Re: **800 Rushmore Avenue**  
**Mamaroneck, NY**  
**Tax Lot # 9-38-15**

## ANNOTATED SITE PLAN

## 800 Rushmore ave, Mamaroneck

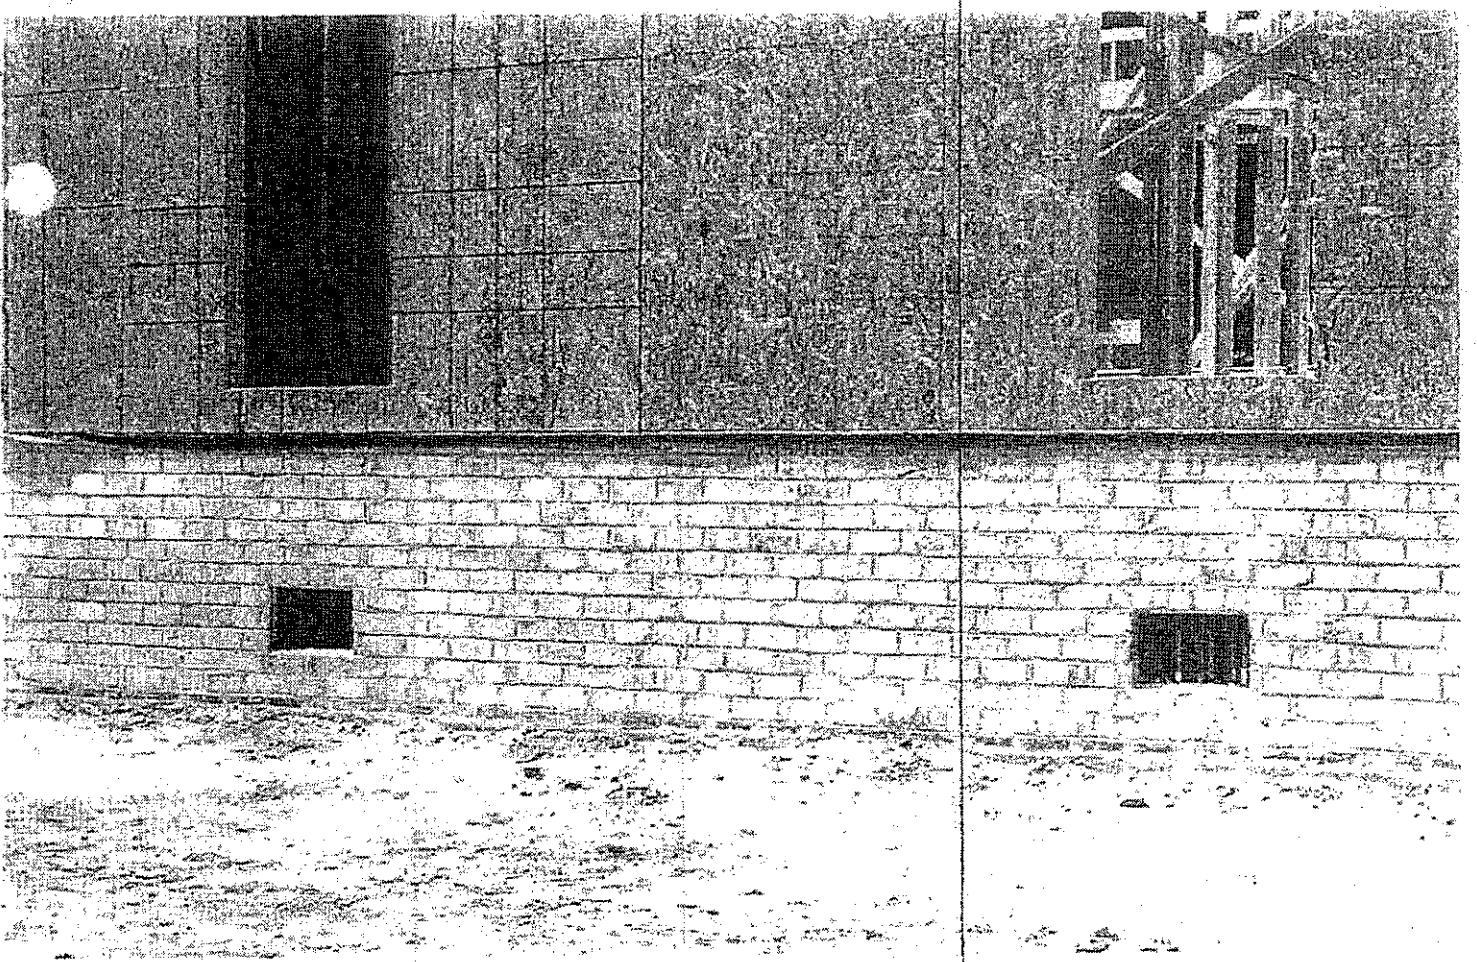
The basement modifications will technically comply with the FEMA regulations for pre-FIRM structures with basements undergoing renovations in excess of 50% of its value. Future Homeowners however will likely be confused with a pipe directing flood waters to their home and will likely plug the pipe and install a sump pump. The Site Plan therefore should include a clear explanation of what the pipe is for and the need to maintain it unobstructed and free flowing in both directions. Also the Site Plan should explain the permitted use of the former basement area going forward.

The applicant is also proposing to raise the garage to elevation 14.0. Based on the grading provided this will result in a 10% grade entering the garage in the area cars will park. This is extremely steep for a residential parking area. The applicant could easily reduce the grade to 5% by maintain the existing 12.0 elevation within the driveway which will provide a much more manageable slope up to the garage. The driveway will also have a 3 foot high drop off from its edge in the vicinity of the garage. Either a railing should be provided of the area graded to a gentler slope.

The applicant needs to provide a plan which shows the proposed filling within the floodplain as well as the compensatory storage provided to offset the lost floodplain. It would help if the plan were color coded ( per one foot intervals ) and included a chart which show the lost floodplain and compensatory storage at each elevation interval.

The basement modifications will technically comply with the FEMA regulations for pre-FIRM structures with basements undergoing renovations in excess of 50% of it's value. Future Homeowners however will likely be confused with a pipe directing flood waters to their home and will likely plug the pipe and install a sump pump. The Site Plan therefore should include a clear explanation of what the pipe is for and the need to maintain it unobstructed and free flowing in both directions. Also the Site Plan should explain the permitted use of the former basement area going forward.

The applicant is also proposing to raise the garage to elevation 14.0. Based on the grading provided this will result in a 10% grade entering the garage in the area cars will park. This is extremely steep for a residential parking area. The applicant could easily reduce the grade to 5% by maintain the existing 12.0 elevation within the driveway which will provide a much more manageable slope up to the garage. The driveway will also have a 3 foot high drop off from its edge in the vicinity of the garage. Either a railing should be provided of the area graded to a gentler slope.

The applicant needs to provide a plan which shows the proposed filling within the floodplain as well as the compensatory storage provided to offset the lost floodplain. It would help if the plan were color coded ( per one foot intervals ) and included a chart which show the lost floodplain and compensatory storage at each elevation interval.

See Note # 3 & Note # 4 on Revised Site Plan

Garage Floor elevation to remain as approved. See Note # 2

Grades in flood plain to remain as approved. See Note # 1
